Access Compliance Report Public Rights-of-Way (Curb Ramps)

Main Street: SLEEPY_HOLLOW_LN Cross Street: LONE_OAK_CIR Location: NE

ADA ID: RPRK211021135102 Ramp Type: Type 4 - Parallel Initial Pass/Fail: Fail Overall Compliance: No Severity Score: 2

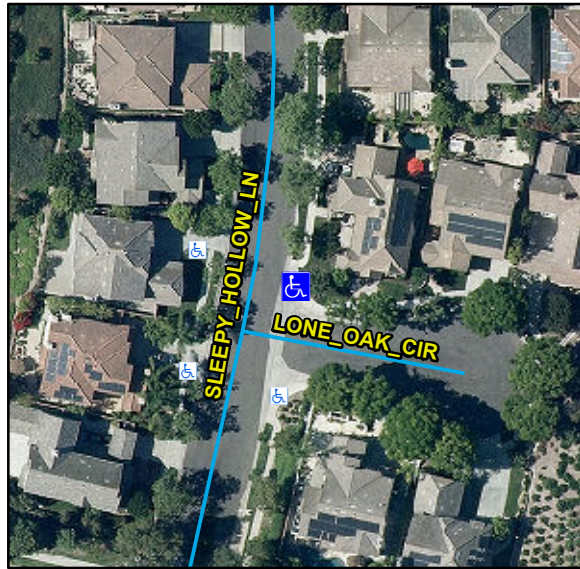
Compliance	Description	Data	Compliance	Description	Data
N/A	Ramp Length LT (in)	115	N/A	Ramp Length RT (in)	114
Yes	Ramp Width LT (in)	53	Yes	Ramp Width RT (in)	53
Yes	Ramp Run Slope LT (%)	6.9	Yes	Ramp Run Slope RT (%)	7.3
Yes	Ramp Cross Slope LT (%)	0.2	No	Ramp Cross Slope RT (%)	2.6
N/A	Landing Present	N/A	N/A	DWS Provided	N/A
N/A	Landing Length (in)	N/A	N/A	DWS Contrast	N/A
N/A	Landing Width (in)	N/A	N/A	DWS Length (in)	N/A
N/A	Landing Run Slope (%)	N/A	N/A	DWS Full Width	N/A
N/A	Landing Cross Slope (%)	N/A		DWS Offset Type	N/A
N/A	Landing Movement Obstructed?	N/A	N/A	DWS Offset Left (in)	N/A
	Landing Movement Type	N/A	N/A	DWS Offset Right (in)	N/A
N/A	Landing Shared	N/A			
N/A	Clear Space	Yes			
N/A	Clear Space To Crosswalk (in)	N/A			
N/A	Marked Crosswalk 1	No	N/A	Marked Crosswalk 2	No
	Crossing 1 Direction	NW		Crossing 2 Direction	SW
	Marked Crosswalk 1 Width (in)	N/A		Marked Crosswalk 2 Width (in)	N/A

Remove & Replace Curb Ramp With Two New Directional Ramps or Equivalent.

R304.5.3, STD 1115
